# Memorandum

Subject: Ensham - Life of Mine Extension Zones 2 and 3  
Response to Requirement notice dated 29 March 2022

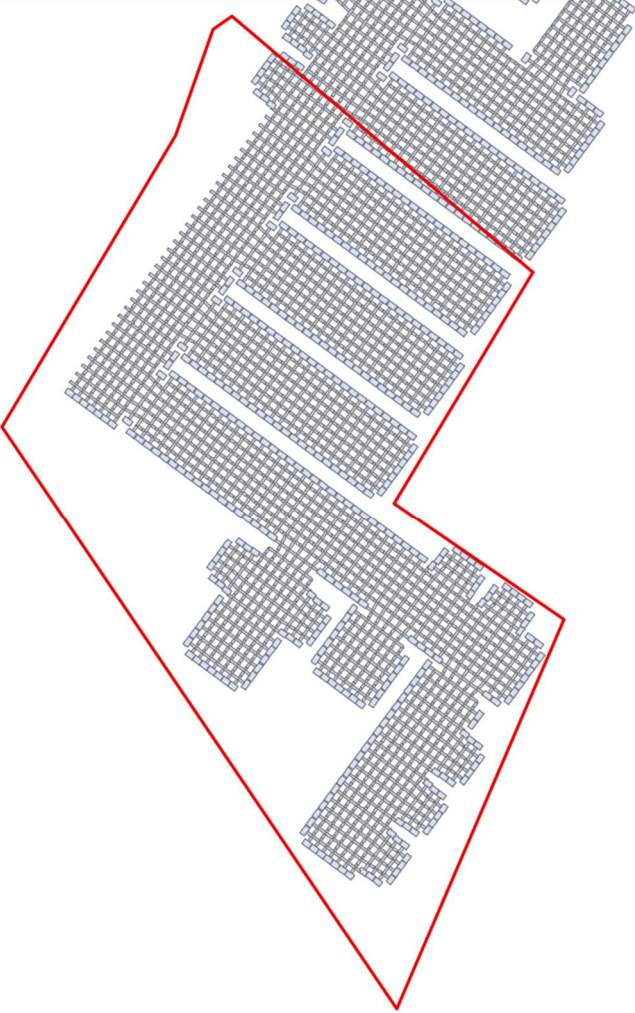
23	The spatial data provided for the underground mining activities details that these activities encroach subterranean areas under both Lot 06TT309 and a road reserve parcel adjacent to Zone 2. This encroachment occurs in eight locations. These activities also were identified to exceed the boundary of Zone 2 in two other instances (Refer to images below).	Confirm and update relevant assessment application material.	The spatial data has been updated to reflect actual underground mine workings for Zone 2 are within the Zone 2 boundary. The boundaries are presented below and the updated spatial data has been attached with this application.
